Progress of overall tunnel design toward the basic design

H. Hayano KEK

CFS design flow, currently on-going

4)Chicane of e- LTR interfere with e+ BDS.

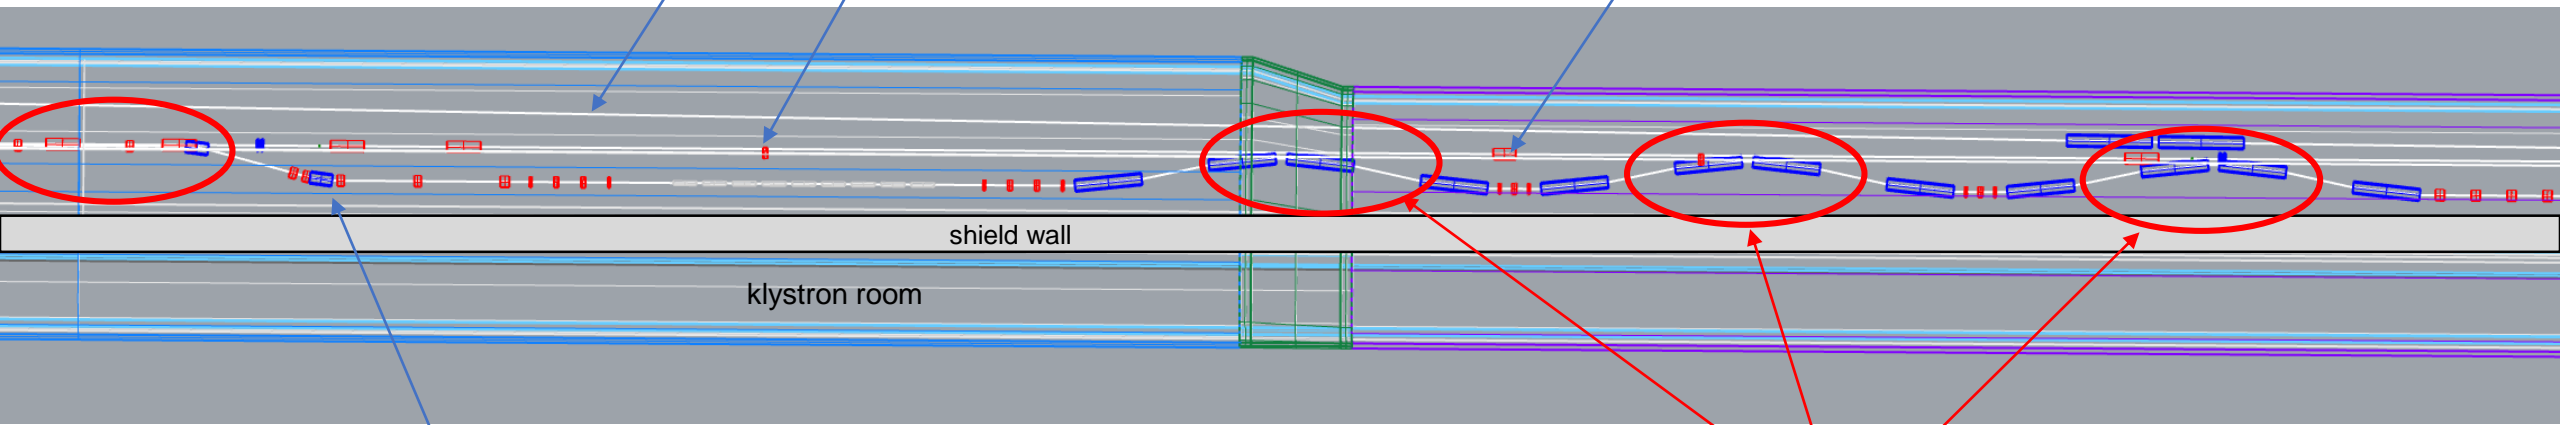
Beam lines interfere

Moved e- source to PM+8 (plain view)

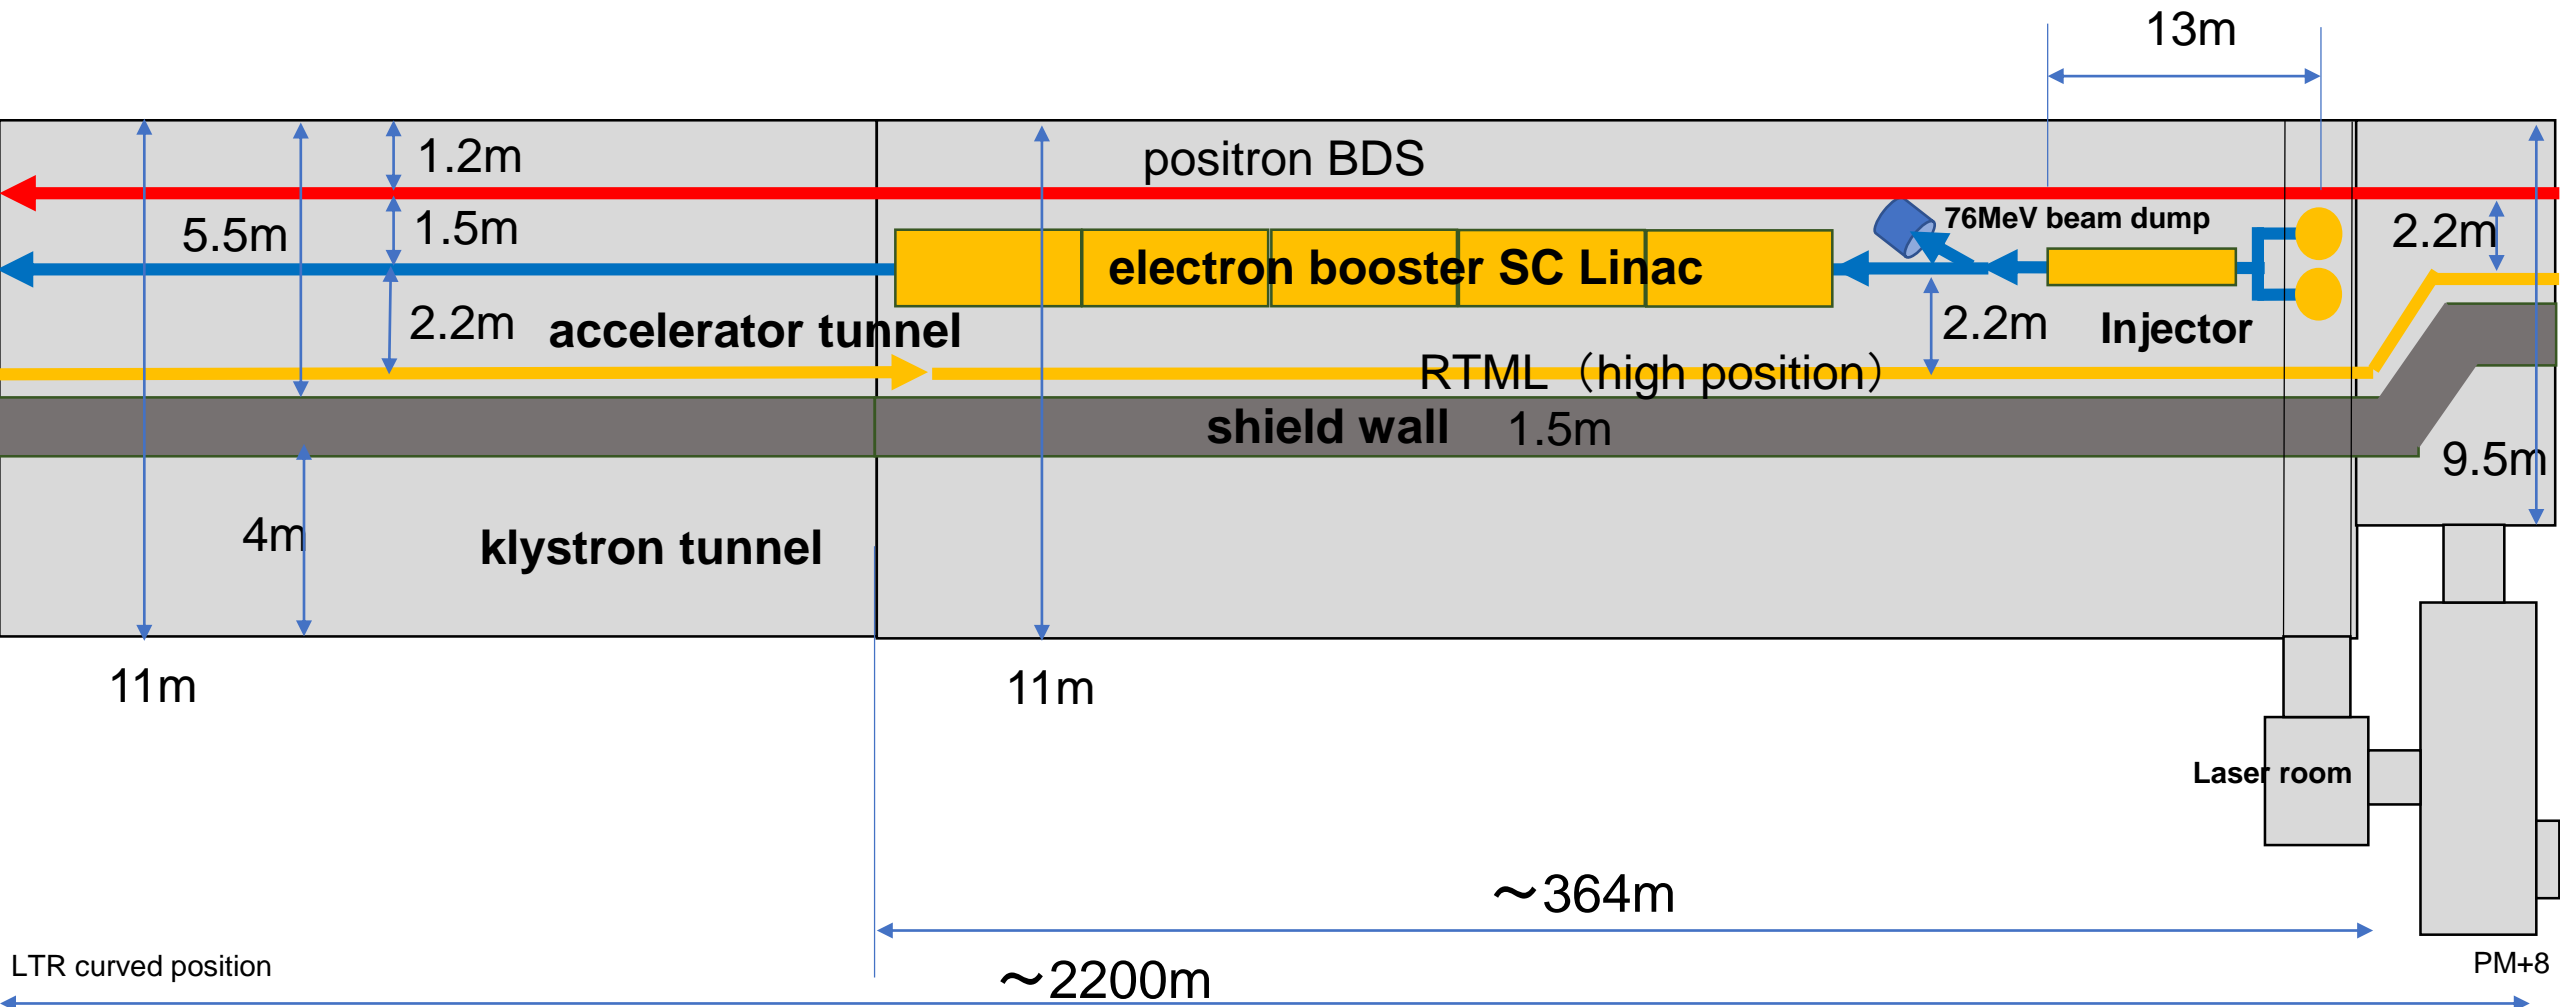
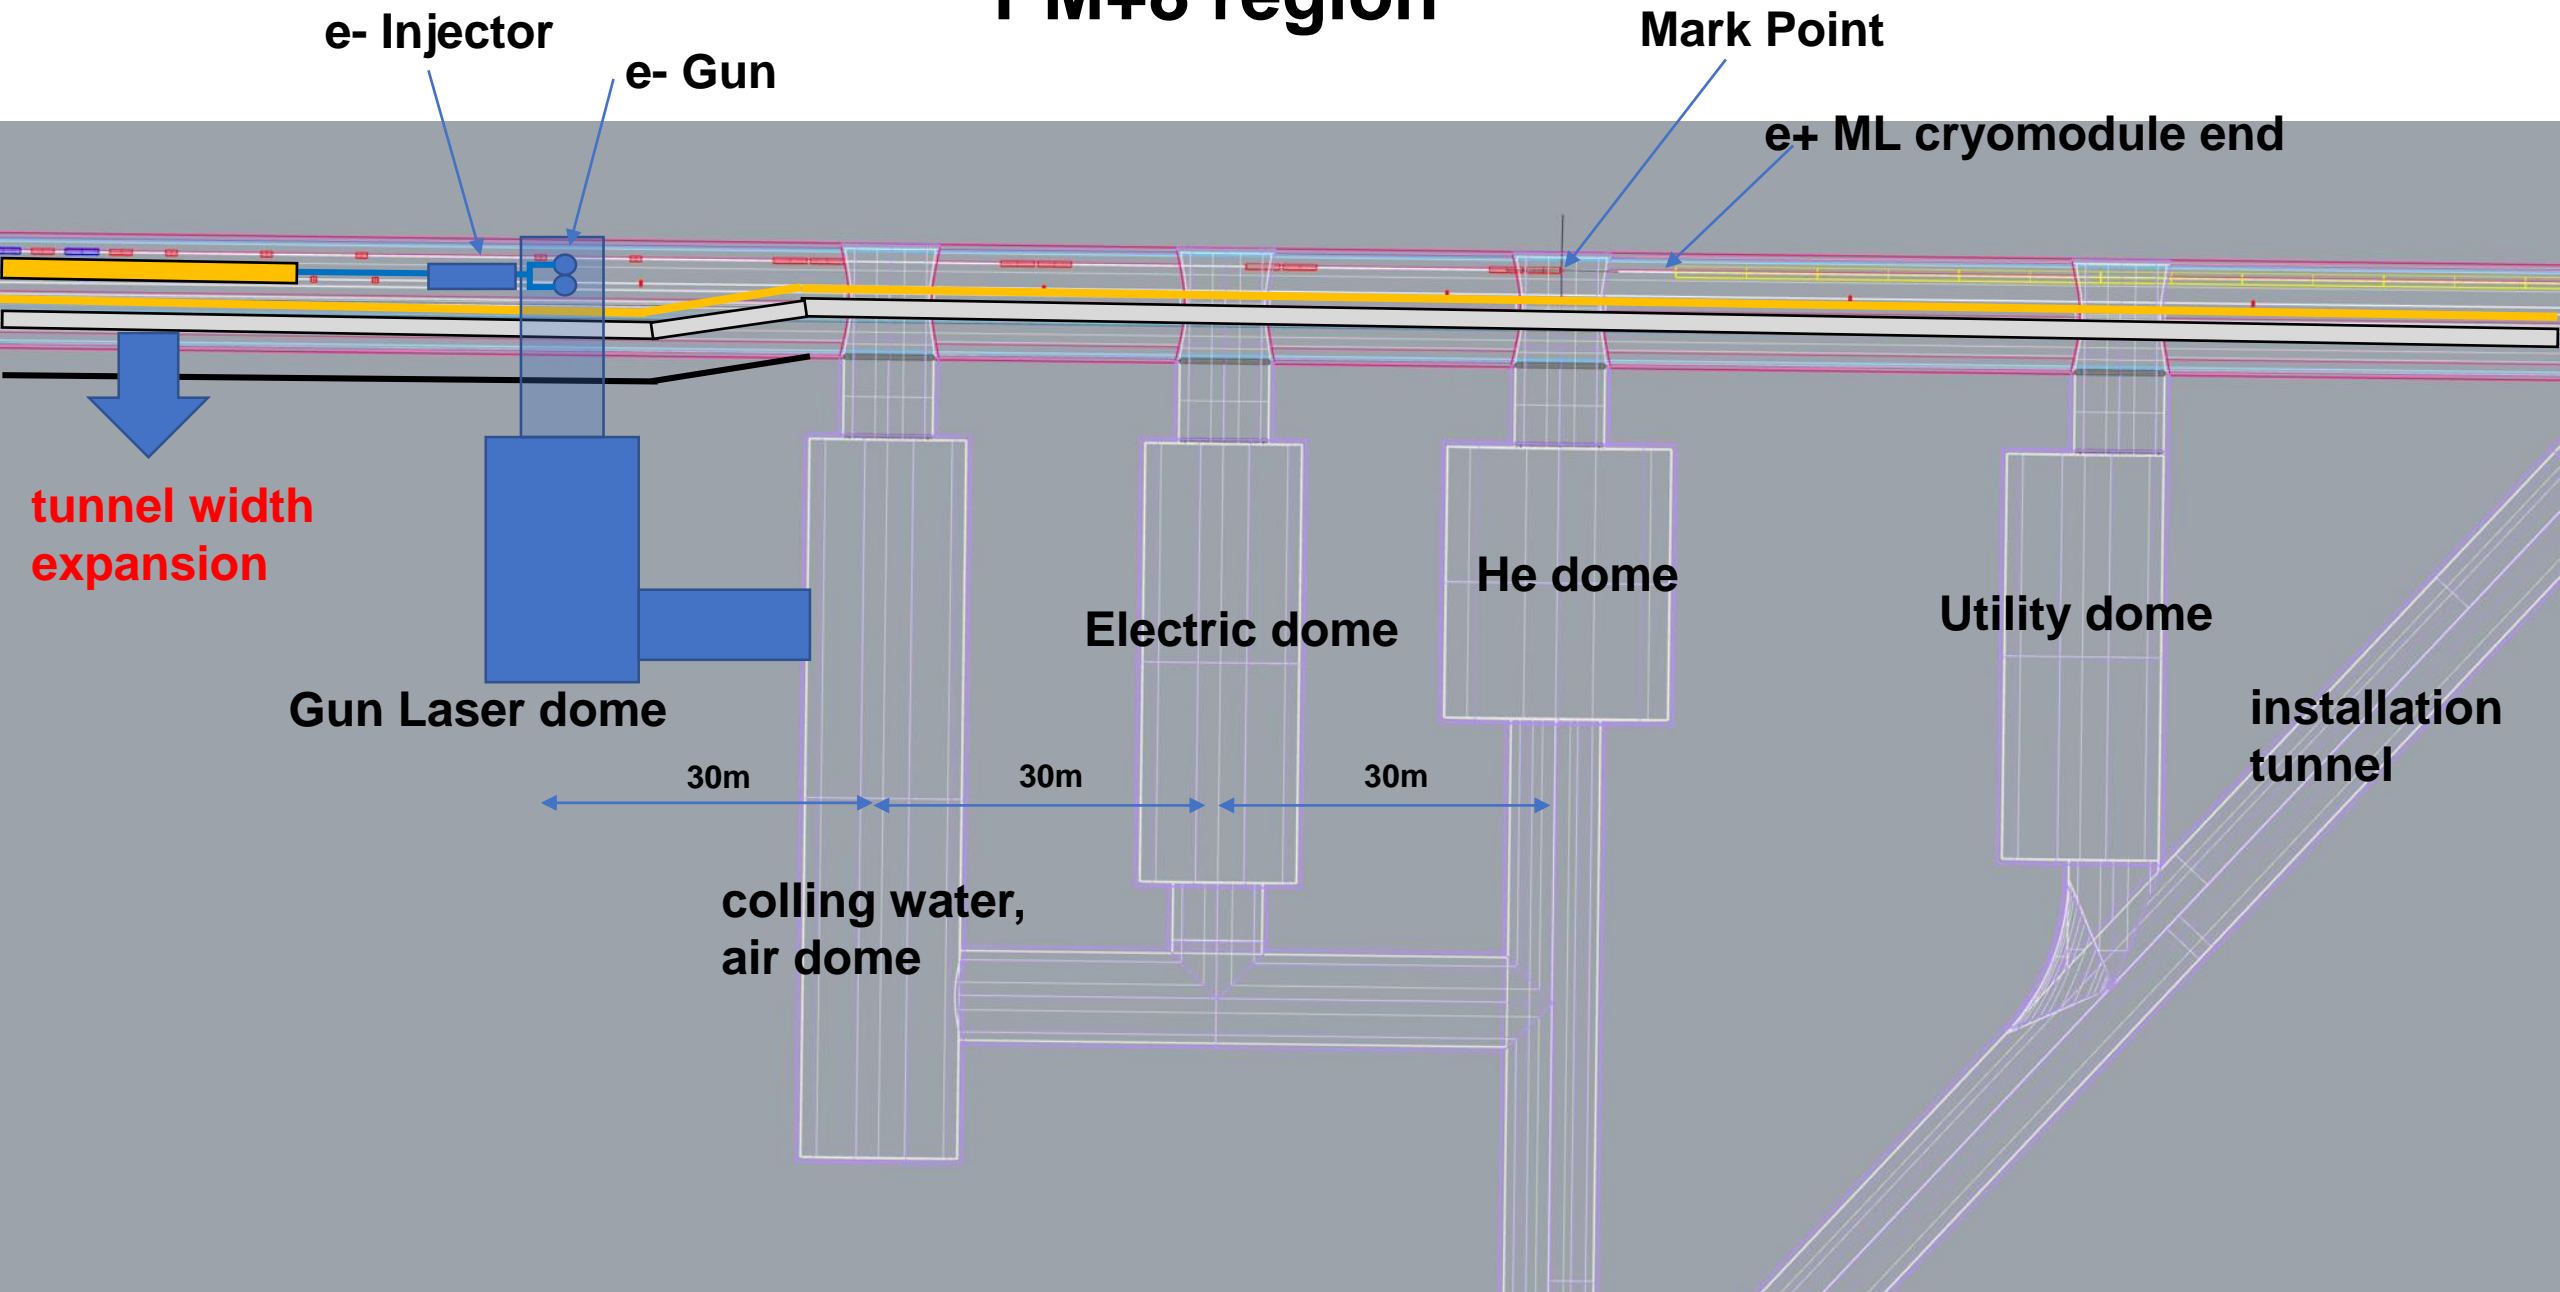
**7) Place of e- source and booster Linac are far away from access hall.
Gun laser need daily base maintenance, SC booster Linac is better
to close to He supply at access hall.**

Location of e- source and booster Linac (yellow arrow)

Cross section of 11m width tunnel for e- booster LINAC, e+BDS, e+RTML

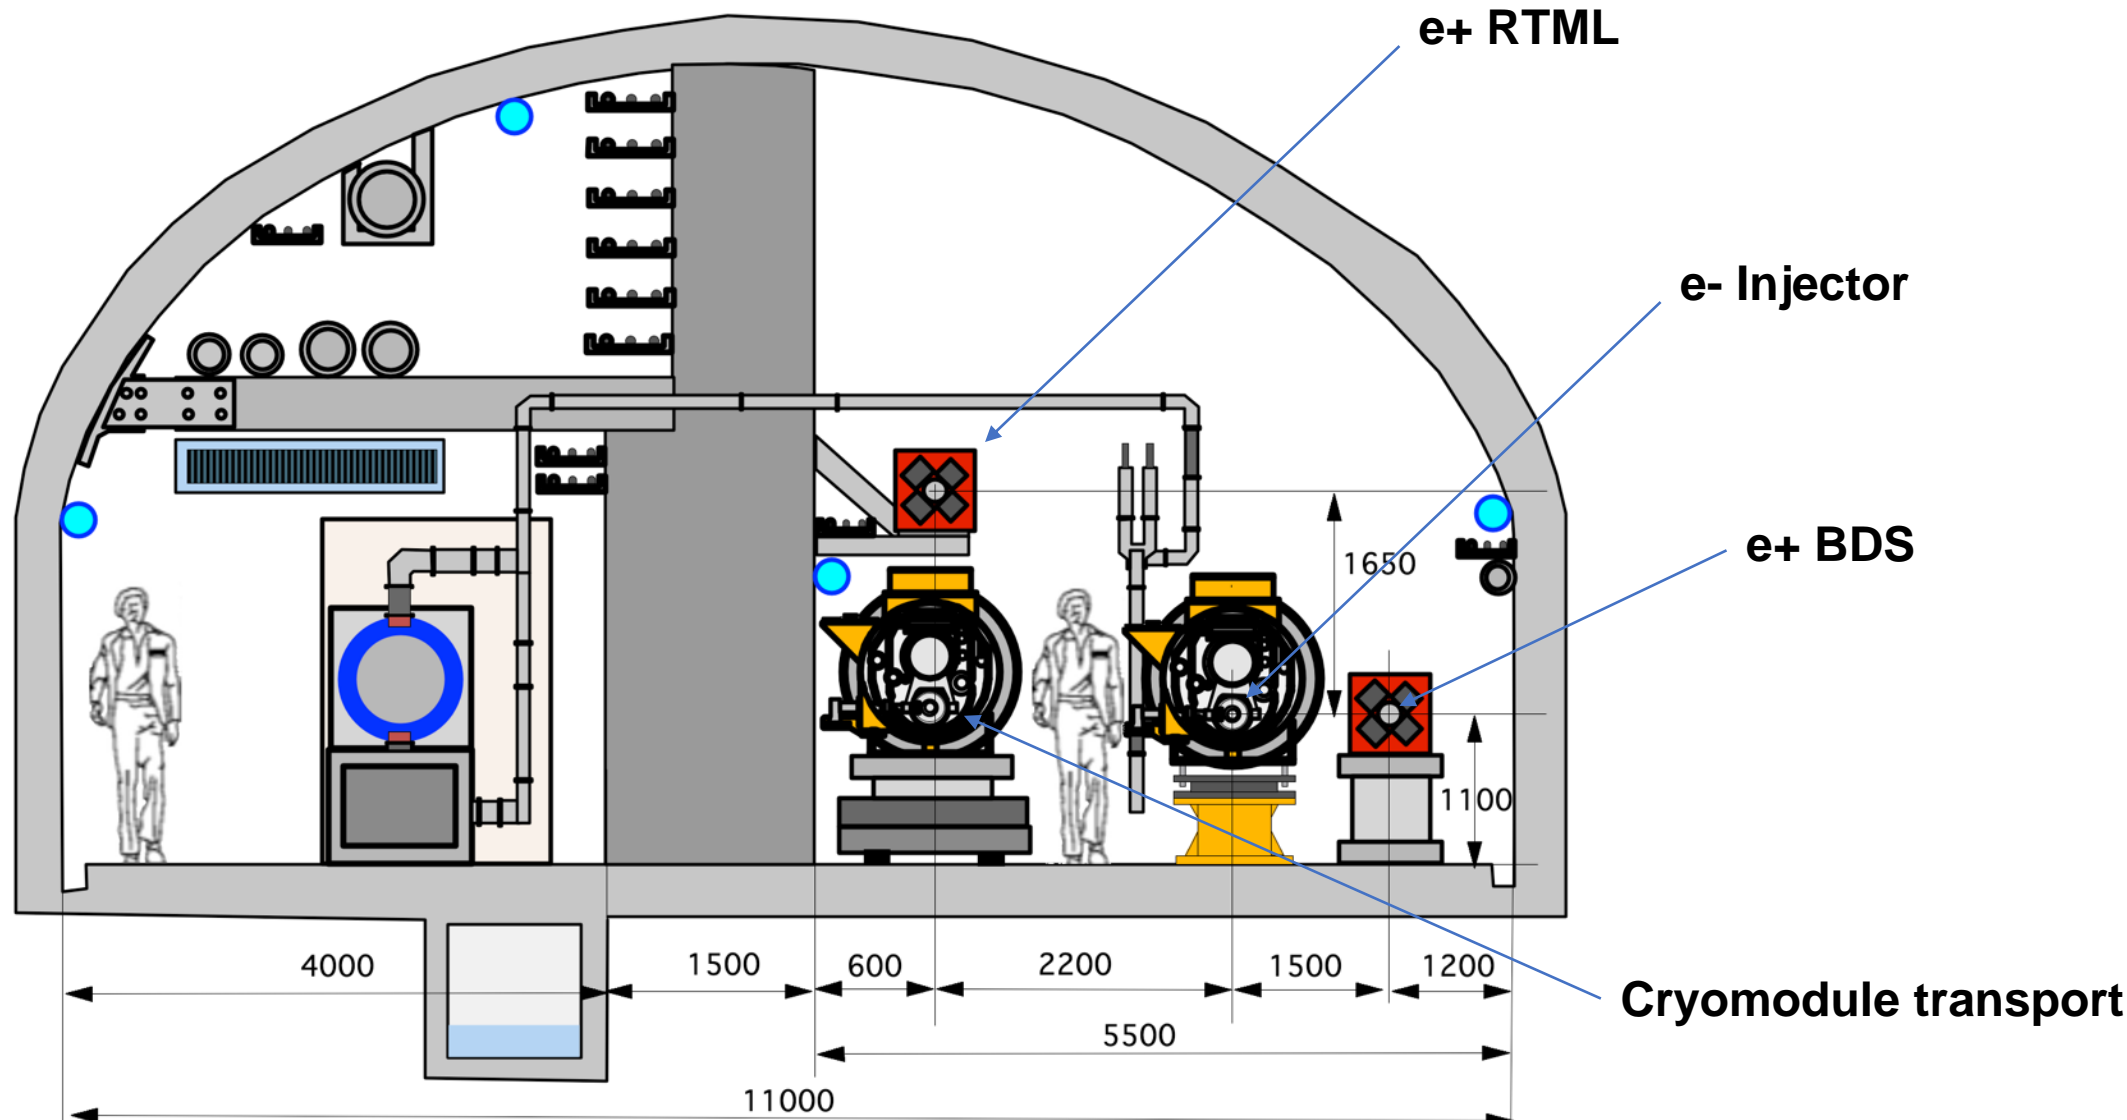
More consideration to the alignment work on BDS, behind the cryomodule, is necessary.
